EARTH LEAKAGE RELAY WIRING UPDATE

Figure 1: Correct Wiring, P6_4 Not Connected

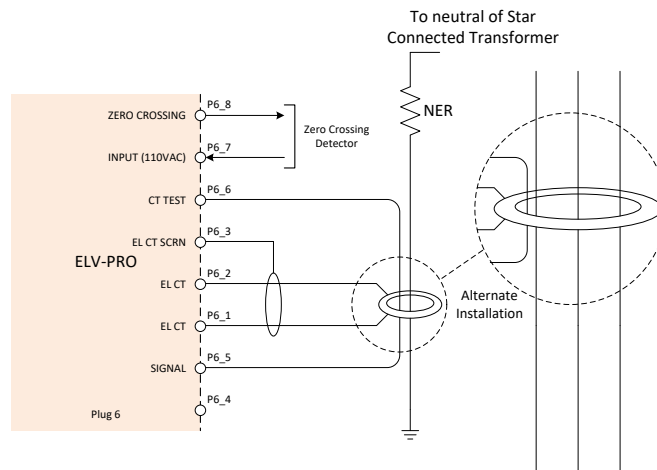
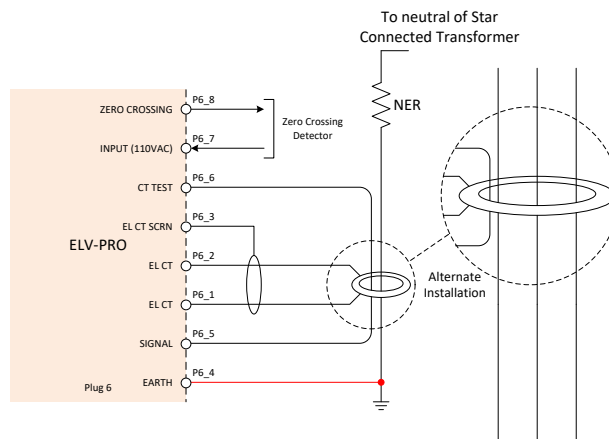
Amcontrol has recently detected an error in the specified wiring requirements of the ELV-PRO Earth Leakage Relay. The error originates from the transition from the VSD Guard to the ELV-PRO, which was an incorrectly identified pin, Plug 6 Terminal 4. The VSD Guard labelled this as a 'Shunt Earth' connection, whereas the ELV-PRO removed the Shunt wording, repurposing it as a general earth connection as opposed to removing the connection requirement.

There are no safety implications of this connection being made. It has been identified however, that additional noise can be coupled into the relay causing difficulties with CT detect and nuisance EL readings being detected through the live web server interface.

The wiring error is illustrated in the below images. Figure 1 outlines the correct wiring installation, while Figure 2 shows the incorrectly added earth connection and labelling.

To ensure the relay functions with minimal impact, it is recommended that this connection be removed from any installed relays. If an installed relay is not experiencing CT detection issues or is not seen to be affected by noise coupled into the detection circuitry, there will be limited improvements by removing this connection immediately. In this instance, the wiring update can be delayed until the next suitable maintenance shift and access to the relay is possible.
